From: [REDACTED]
To: [REDACTED]
CC: [REDACTED]
Sent: 2/23/2021 2:13:56 PM
Subject: RE: O8W-PM [REDACTED] - Bucks Creek 1101 Phase 1,2&3 -
Pre-Engineering Meeting
Attachments: Basemap Limits for PM's [REDACTED].kmz

Bucks Creek 1101- PM# [REDACTED] Overview Map

Subject: O8W-PM [REDACTED] - Bucks Creek 1101 Phase 1,2&3 - Pre-Engineering Meeting

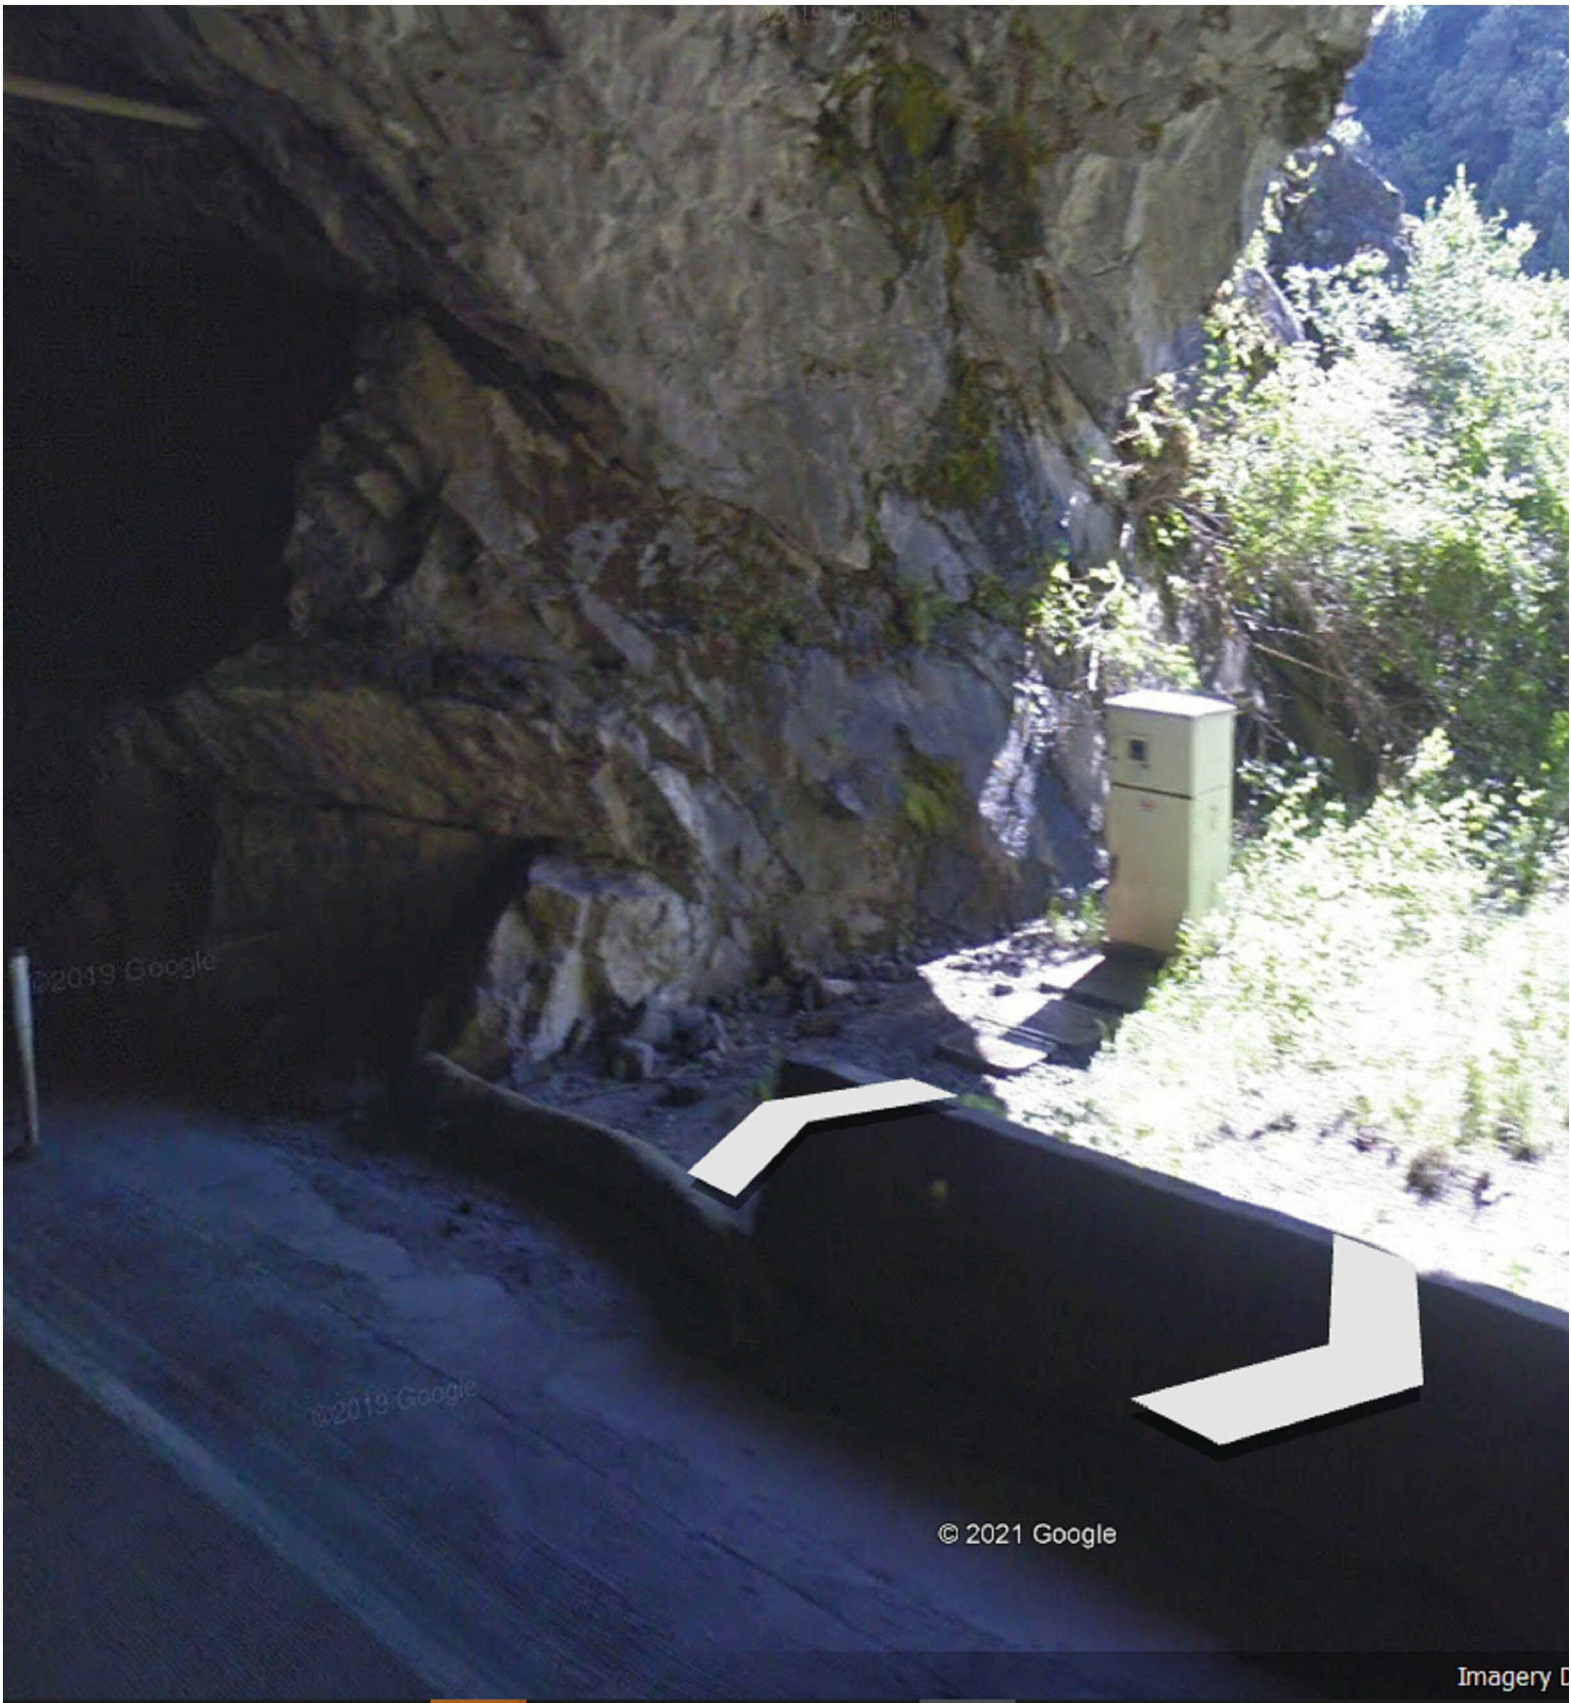
Attached are the 'base-map' limits in a kmz. file. As you will see, we need our base-map to go about ~100' into the tunnel at the south end (see pedestal in picture below....please begin about ~50 beyond this point which is about ~100' beyond the Cresta Dam).

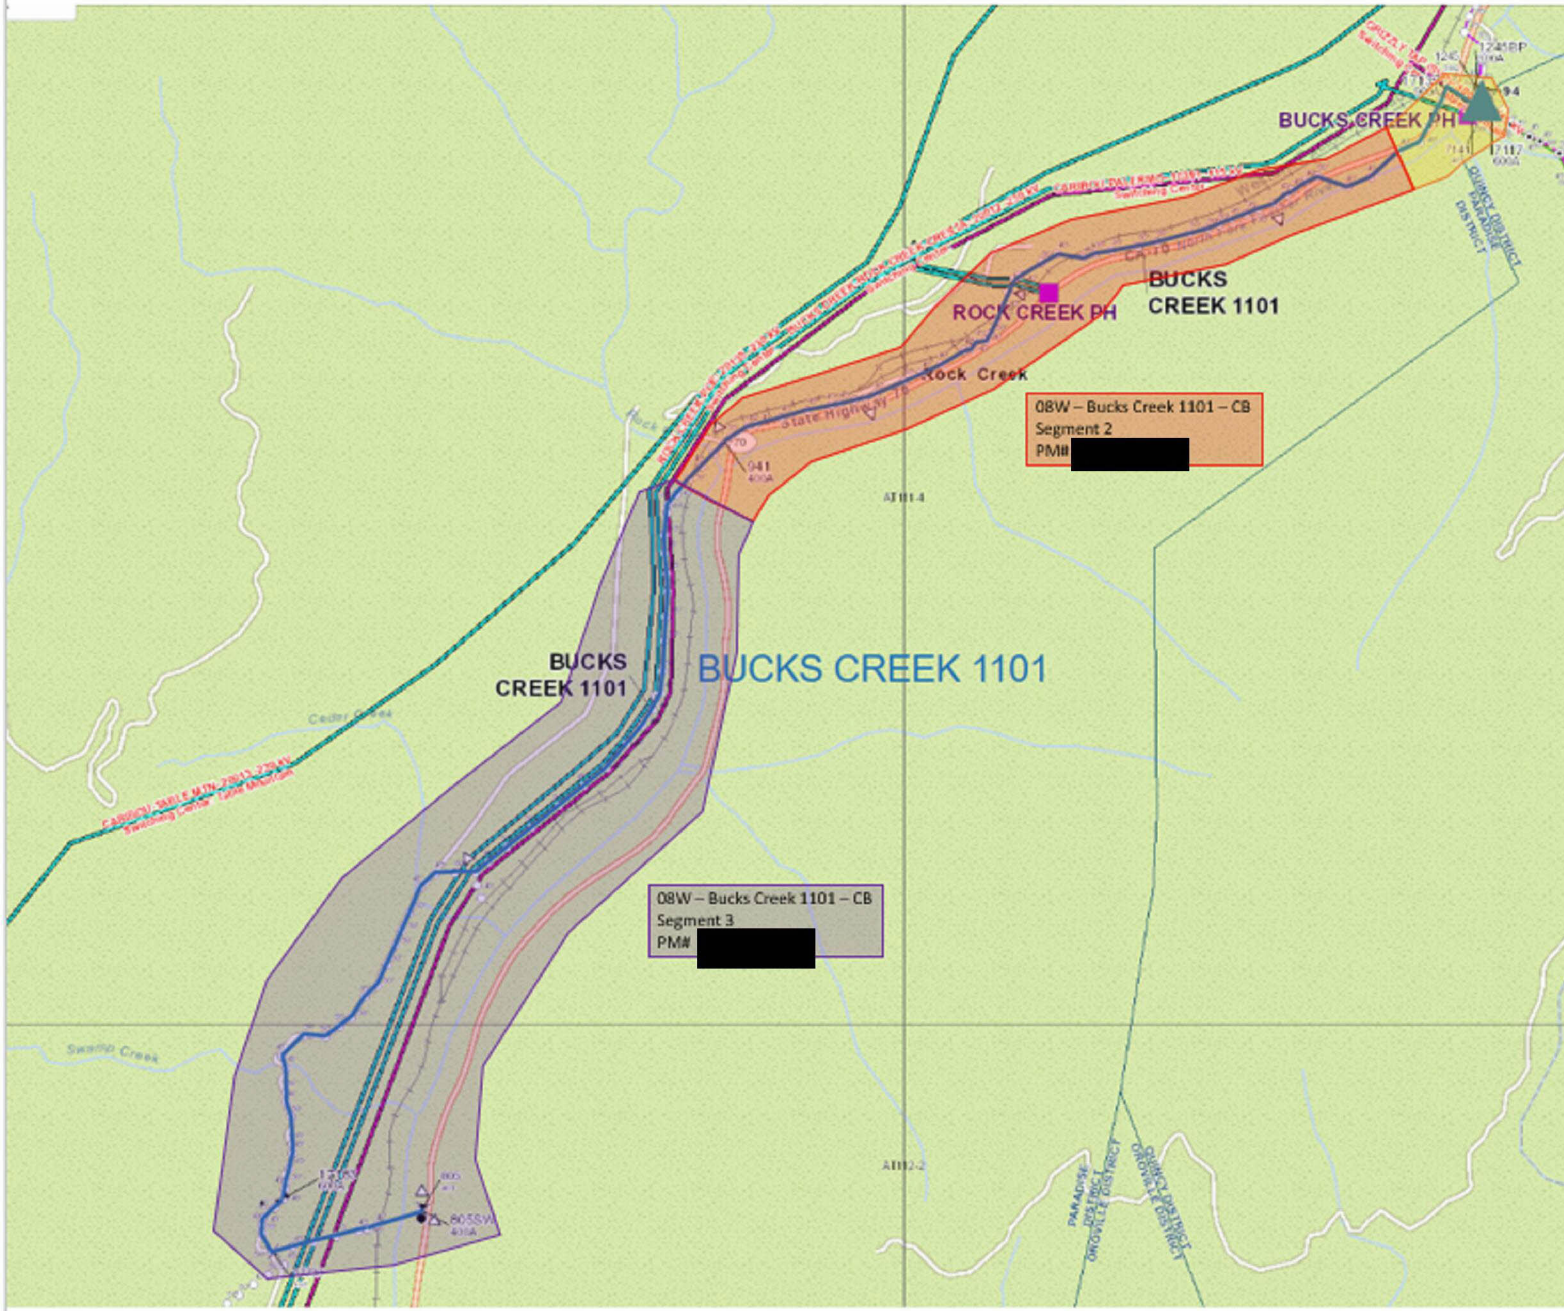
For Bucks Creek there is quite a bit of work surrounding Hwy 70 and we will need a Land Department Base Maps prepared for all 3 Orders. This will delay the EOD dates until these can be developed and provided to the Vendor... We will also need answers to the questions outlined by [REDACTED] below...
